The Reserve at Midway, Phase 2 / Final Approval

CITY COUNCIL MEETING STAFF REPORT

Subject: The Reserve Subdivision Phase 2 – Final Approval

PHASE 2 PRESSURIZED IRRIGATION PLAN

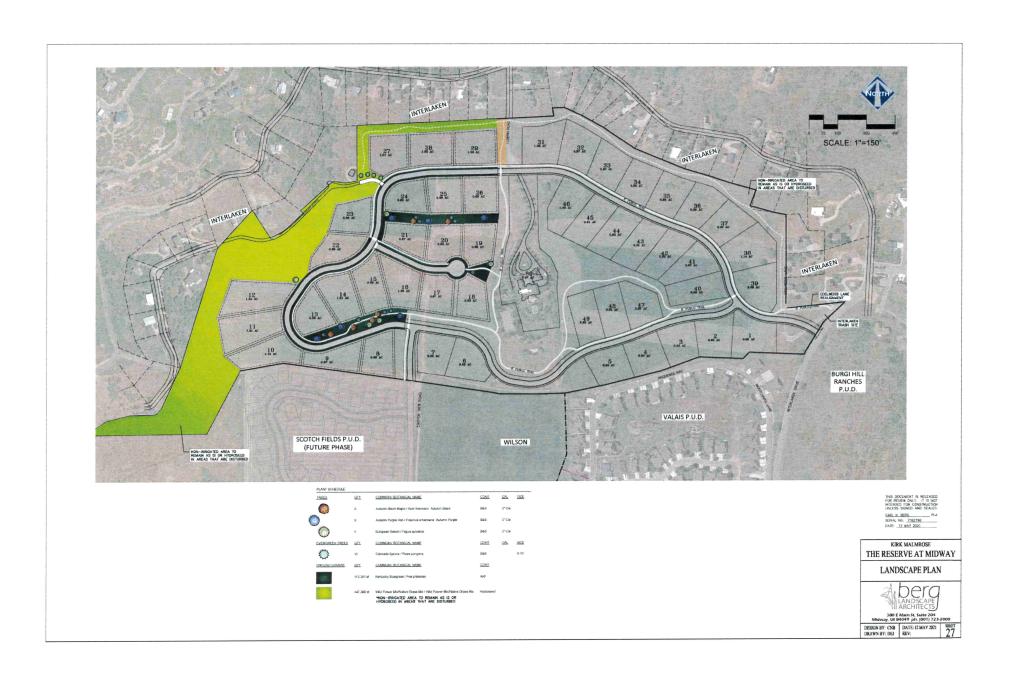
- The subdivision will be serviced by Midway Irrigation Company.
- The irrigation system will utilize a water storage tank that is to be built with phase 1 and private 8" PI lines to serve the homes throughout phase 2.
 - O What is the status of the irrigation tank redlines?
- All removal, additions, or revisions to the pressure irrigation system must be approved by Midway Irrigation Company.
